Service Bulletin

Subject: Noise from Roof Area at Speeds 35 MPH (56 km/h) and Above

Brand:	Model:	Model Year:		VIN:		Engine:	Transmission:
Dranu.		from	to	from	to		
GMC	Acadia	2017	2023	-	-	All	All

6388145

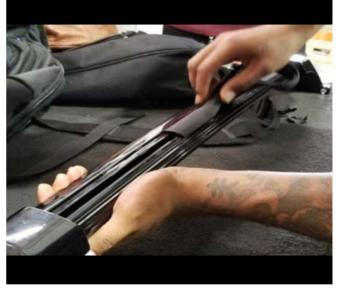
- AB = Above Bar and Below Bar
- A = Above Bar
- B = Below Bar

If you encounter a vehicle with the rub strip above, above and below, or appears to be sitting on top of the cross bar as seen here, follow the rub strip replacement procedure below:

- 1. Remove affected Cross Bar from vehicle.
- 2. Place Cross Bar assembly on work bench.

6388147

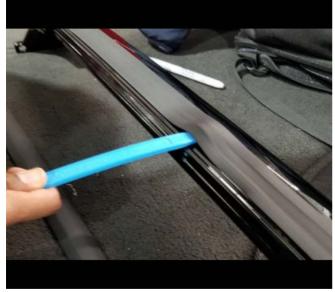
3. Locate the center of the top of the bar where there is a rectangular opening under the rub strip.

- 4. Using a Plastic Trim Stick, lift the rub strip at the center of the bar and pull it out of the track from the center outward to one end, then do the same in the other direction and remove it from the bar.
- 5. Wipe the bar down with a clean cloth
